Amendment 1

Amphitheater Public School AHS – 500 Wing Renovations

AMENDMENT ONE – Date: April 29, 2022

Site Plan

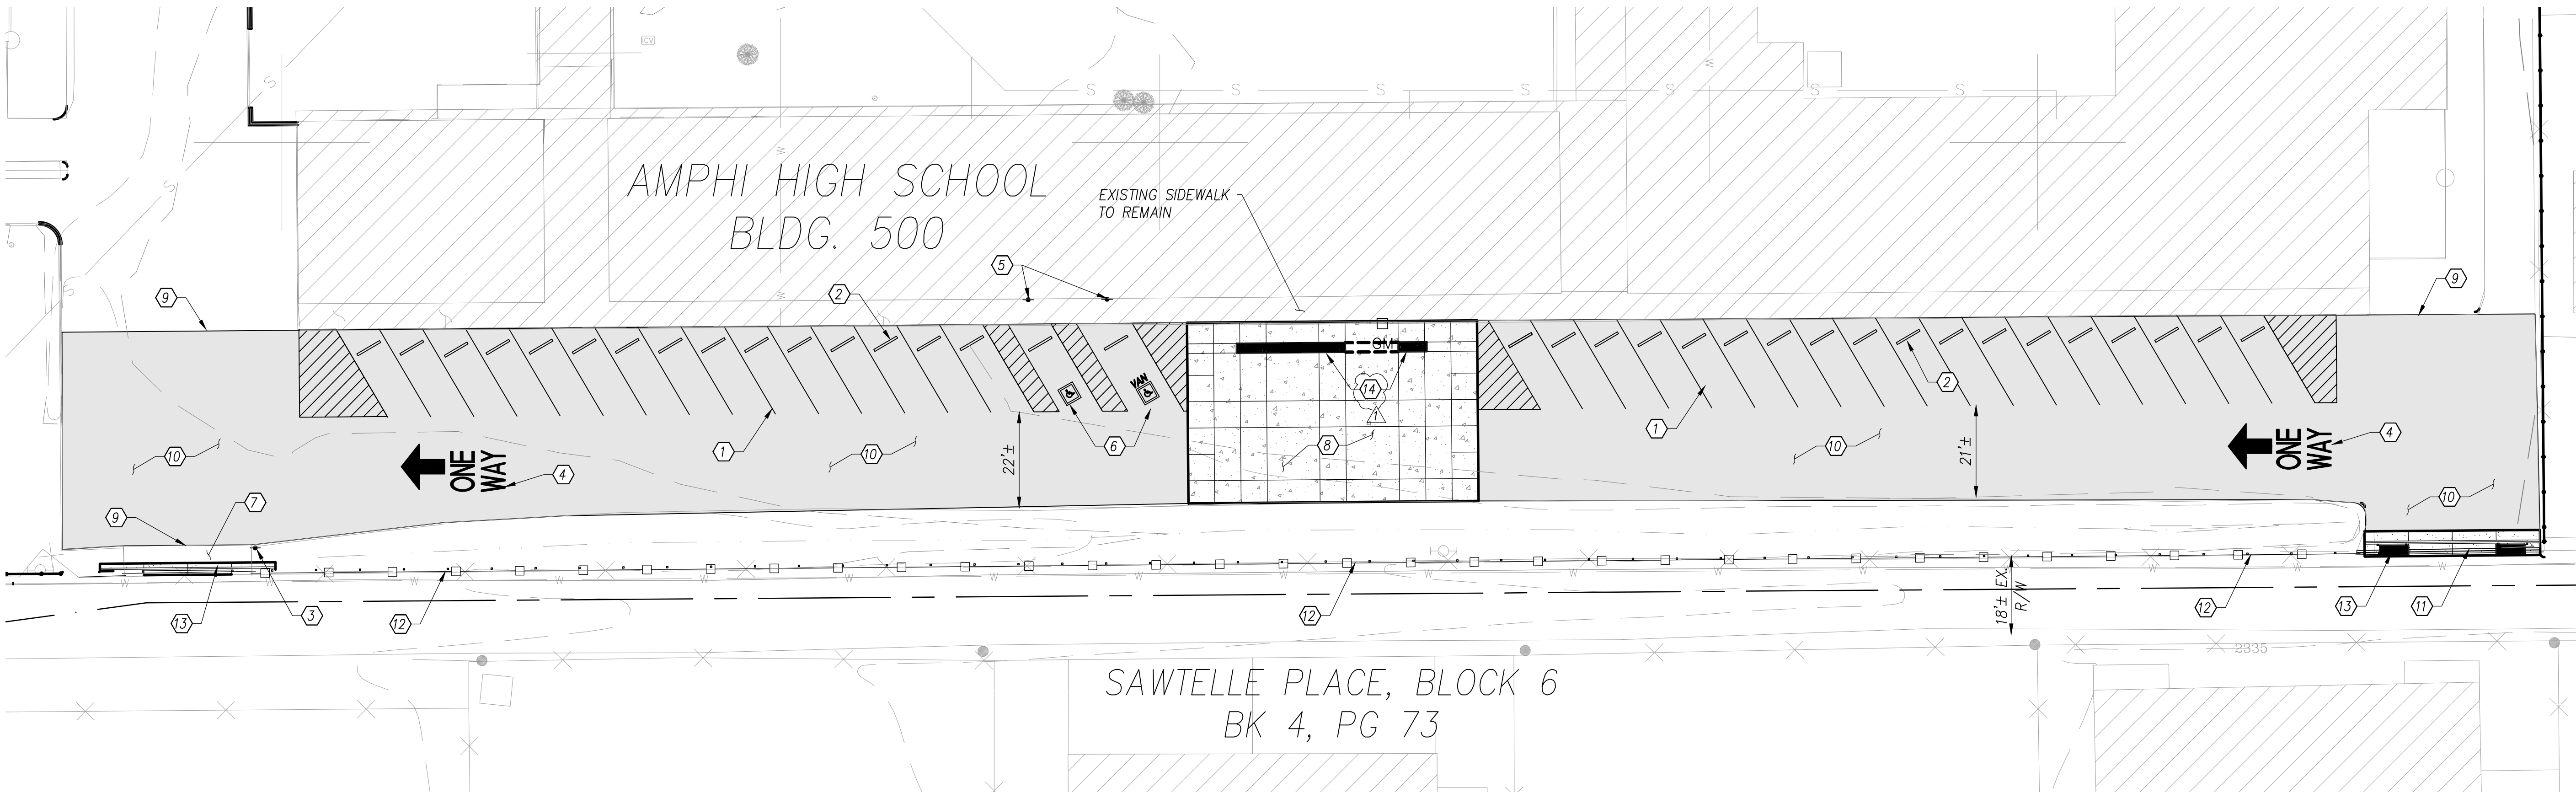
CIVIL	Drawing C1 Keynote 6 in the hardscape points to the monolith, but calls for ADA parking space. Please confirm no parking or designated parking on the new hardscape.	This keynote 6 was labeled incorrectly and have been changed to keynote 14.
ARCH	Drawing AS1.1 multiple reference to AS1.0 in the detail sections. AS1.0 not provided. Please provide or clarify AS1.0 reference.	References from AS1.0 have been changed to AS1.1
ARCH	AS1.3 shows wo monolith structures, one at building 500 per detail 1 on AS1.2, and one smaller monolith at Stone Ave per detail 1 on AS1.2 per the Scope of services there is one additional monolith sign for a total of three. The drawings do not show/reference three signs on AS1.3, on AS1.1, site plan, there is a reference detail on east gate for two of the smaller monoliths (detail 2 on AS1.2) on each side of the gate. How many Monoliths, and what locations?	There are a total of 4 monoliths. 1 large monolith at plaza/entry. 2 smaller ones at east parking lot gate. 1 smaller one by Stone Ave., with lettering.

1. Clarification: Sheet C1 – revised keynote 14
 2. Clarification: Sheet AS1.1 – revised reference callouts
 3. Clarification: Sheet AS1.3 – revised gate callout
 4. Clarification: Sheet AD1.1 – keynote 7 has been added to RCP
 5. Clarification: Sheet A2.1 – revised millwork callout, removed keynote 1 from RCP
 6. Clarification: Sheet A8.1 – hardware information has been added to schedule
 7. Clarification: Sheet A9.1 – revised finish schedule for room 501
 8. Clarification: Sheet A10.2 – revised callouts for details 1 and 5
 9. Clarification: Sheet M1.1 – General Note 10 added, note 3 has been removed
 10. Clarification: Sheet MP1.1 – added detail 1 with controls information
 11. Clarification: Sheet E5.0 – added note for fire alarm system
-

AD1.1

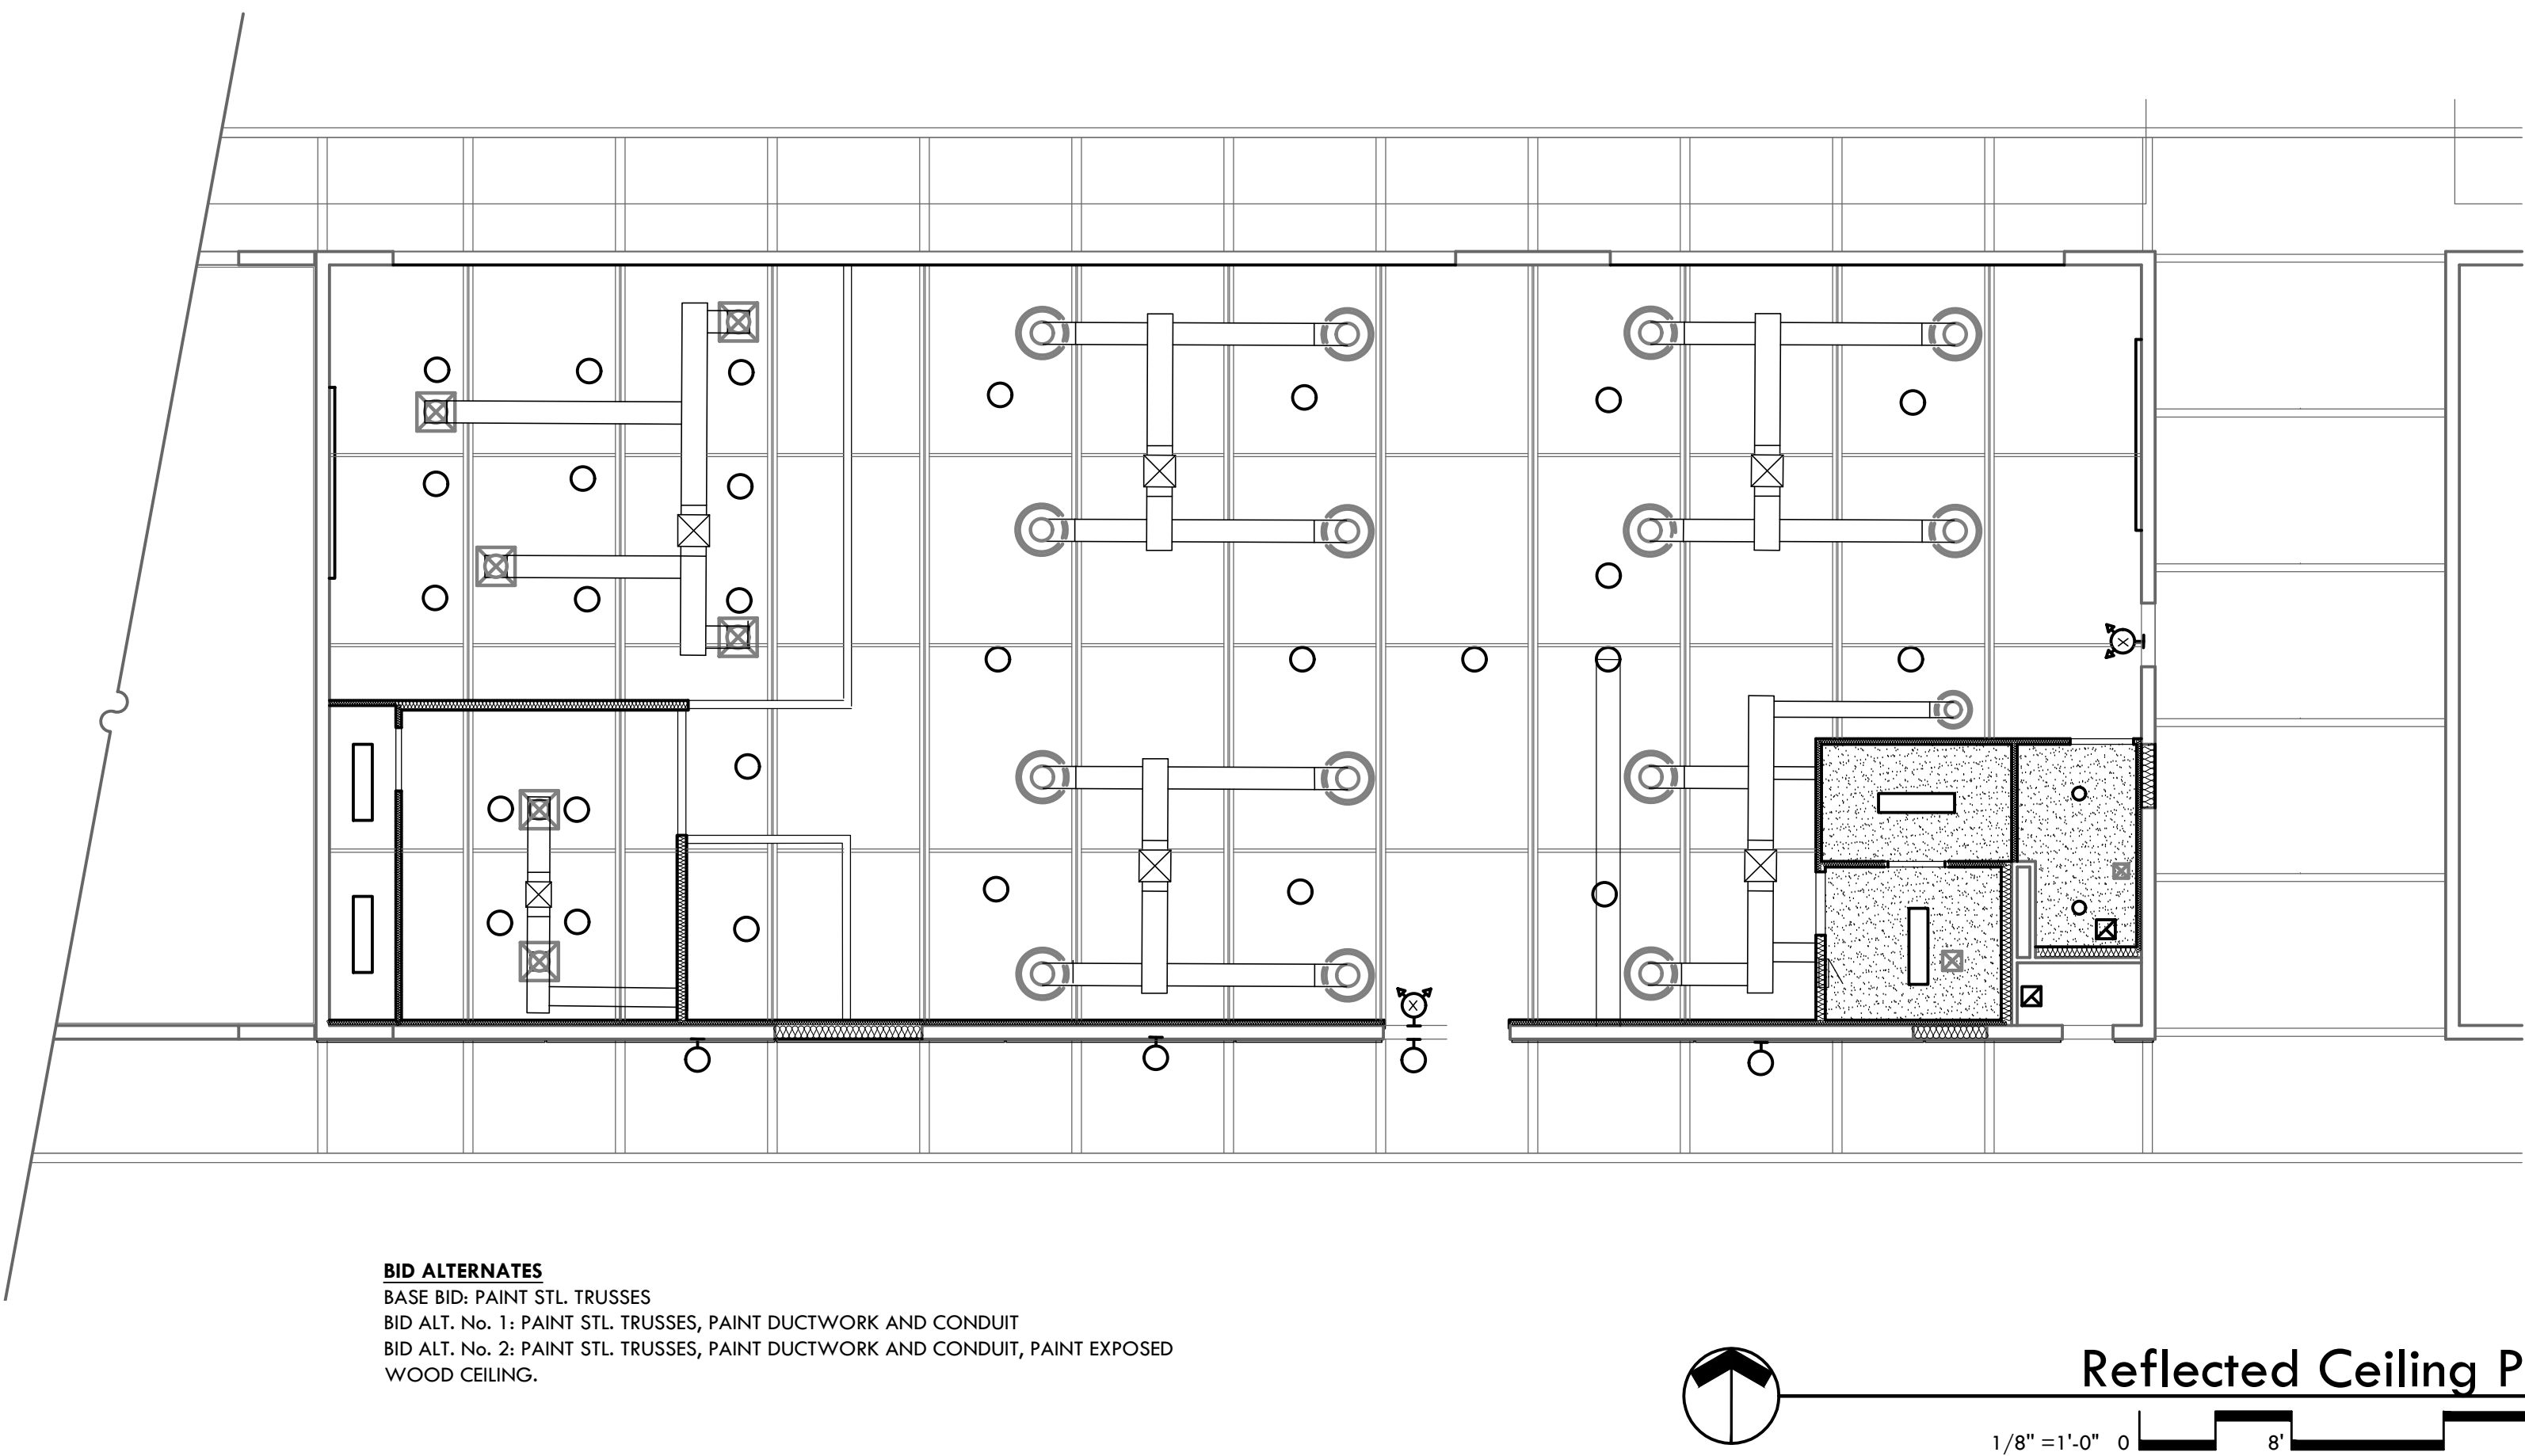
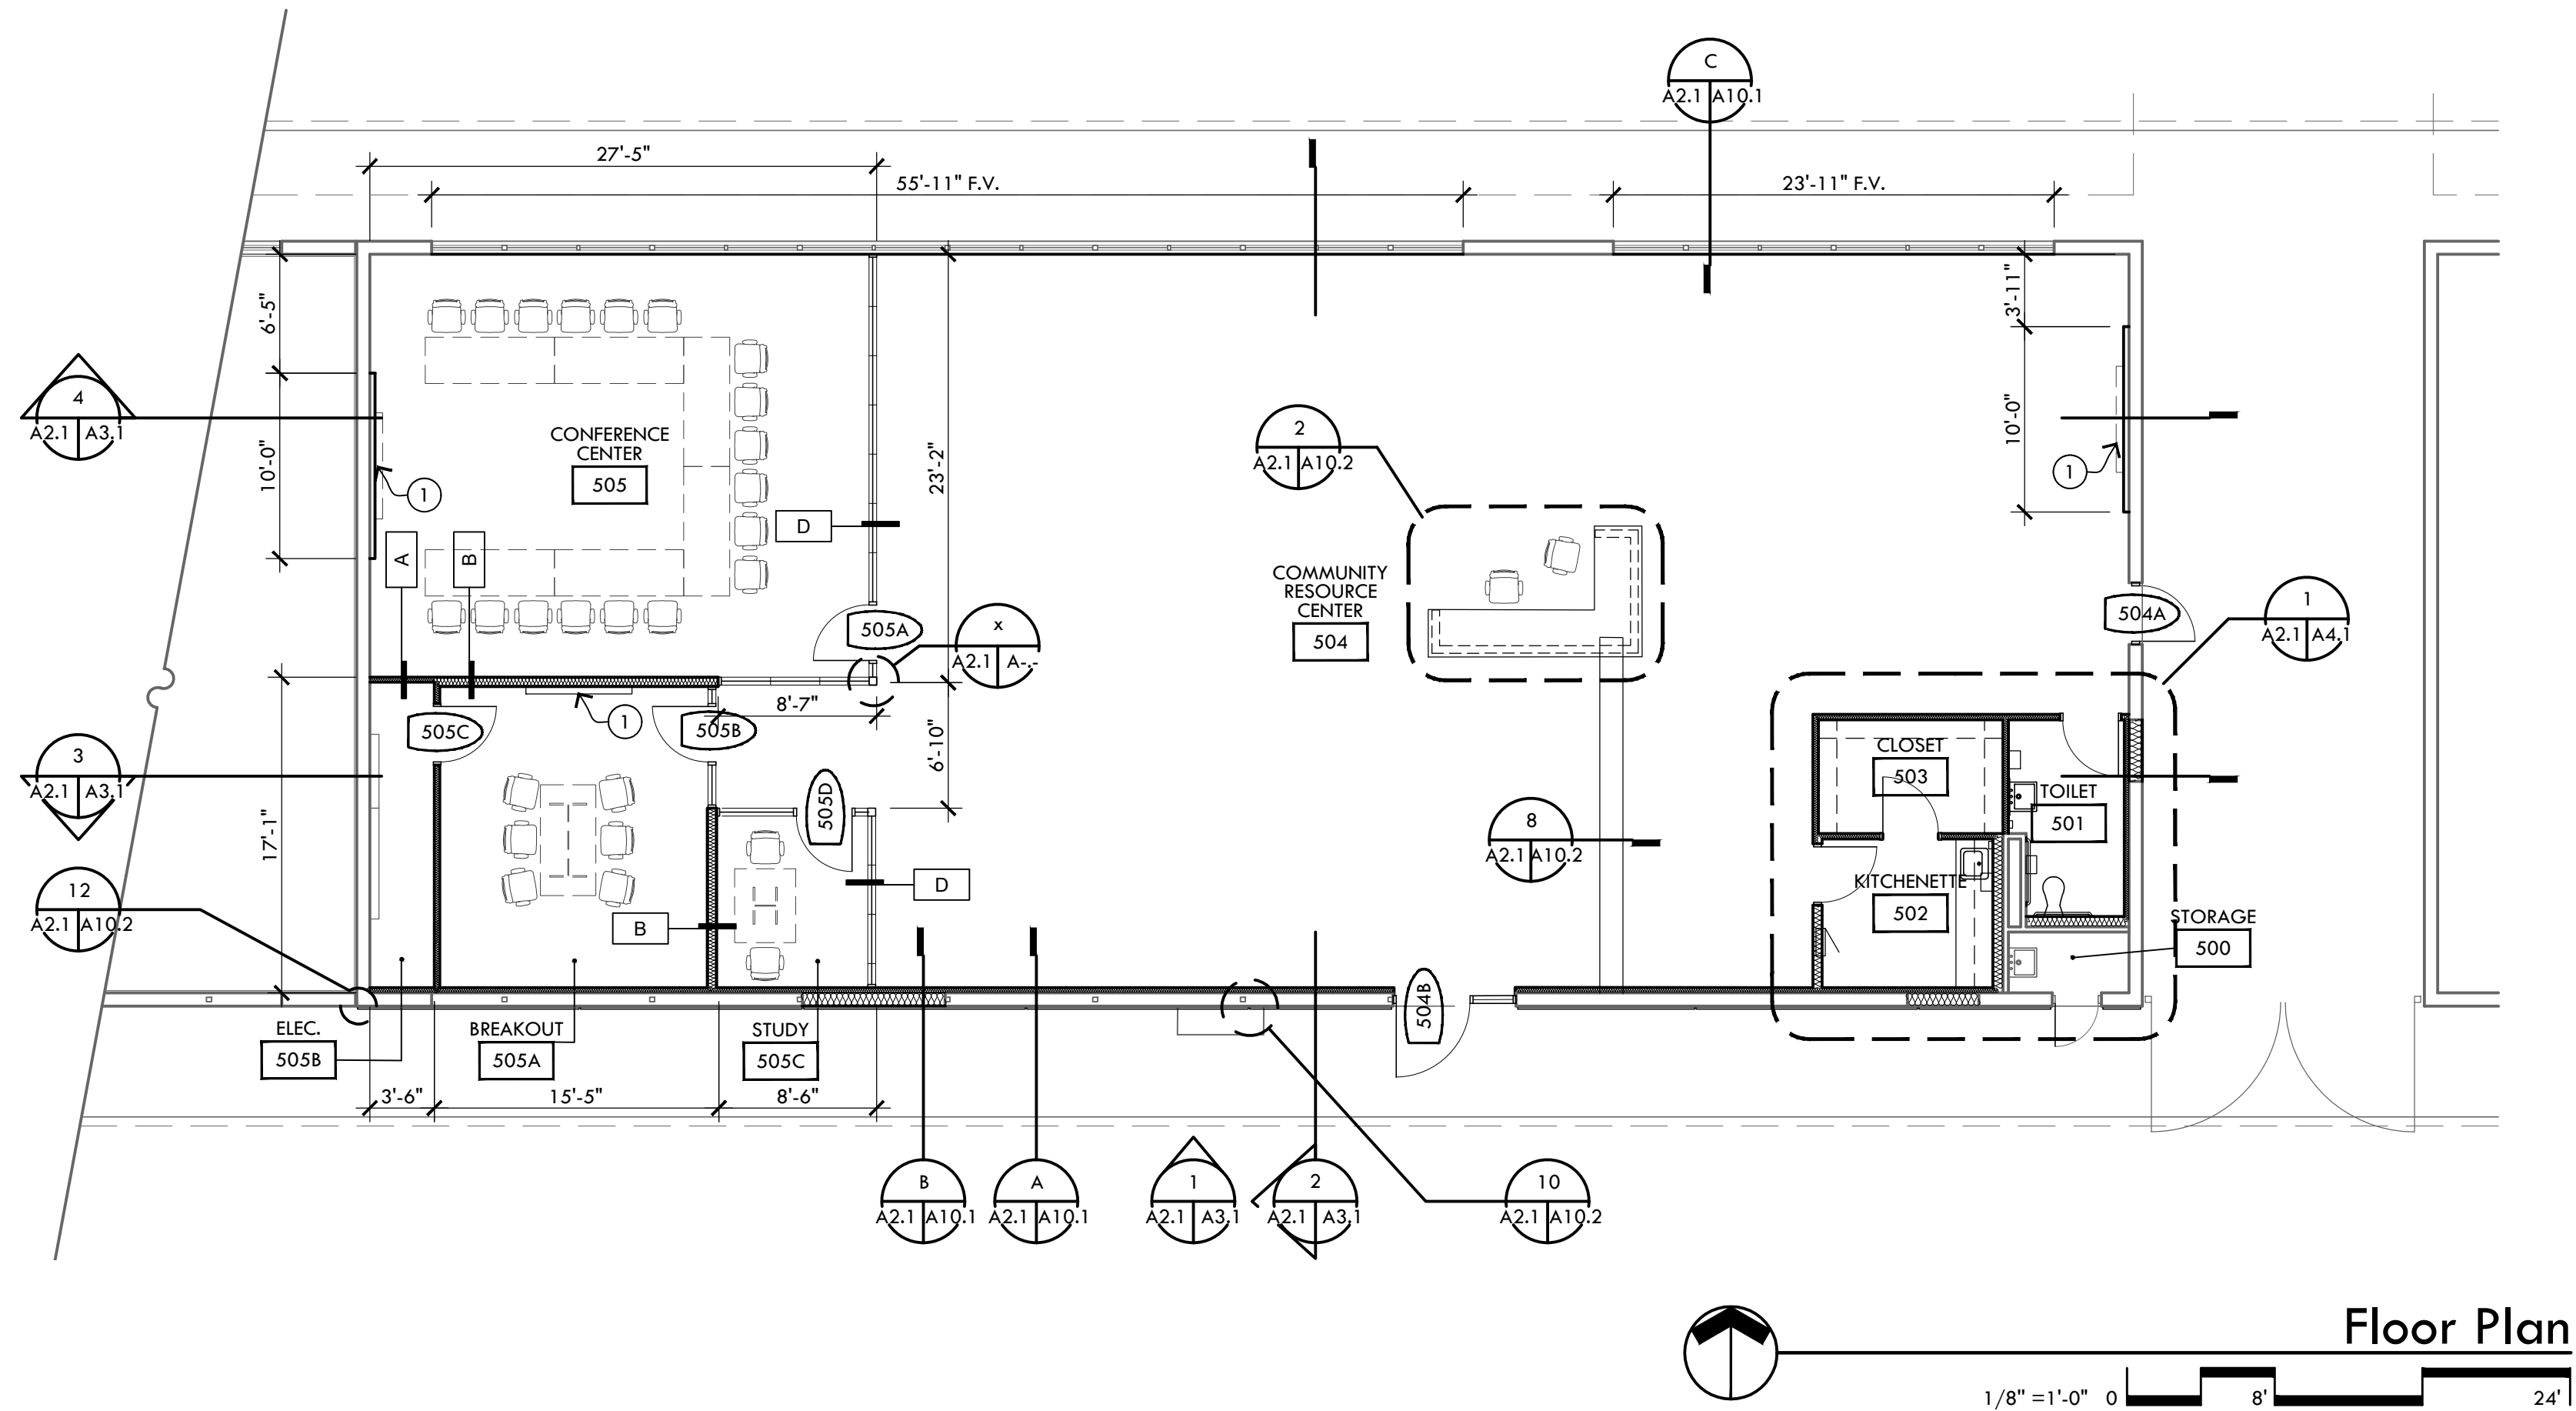
ARCH	AD1.1 There is no reference to Keynote 7 on the demo plan.	Reference for Keynote 7 has been added. See sheet AD1.1
DISTRICT	There are bid alternates shown on the reflective ceiling plan. There are not line items on the bid pricing sheet for bid alternates. How do we show the bid alternates on A2.1?	Bid documents will now be included as line items on Bid Docs
ARCH	A2.1 case work in room 504 reference details on A4.1 There are no details for this case work. Please confirm details for the case work are shown on A10.2.	Reference for caseworks has been changed to A10.2
ARCH	A2.1 keynote 2 states to power was length of exterior wall. Spec section 040120.52 is cleaning masonry walls. Are these the walls that will require cleaning with specified products? Do the interior walls require the specified cleaning?	See sheet AS1.3. Only exterior wall will be cleaned.
ARCH	A2.1 Keynote 1 is shown on the RCP with typ. What is keynote 1 on the RCP reference for?	Keynote on RCP has been removed
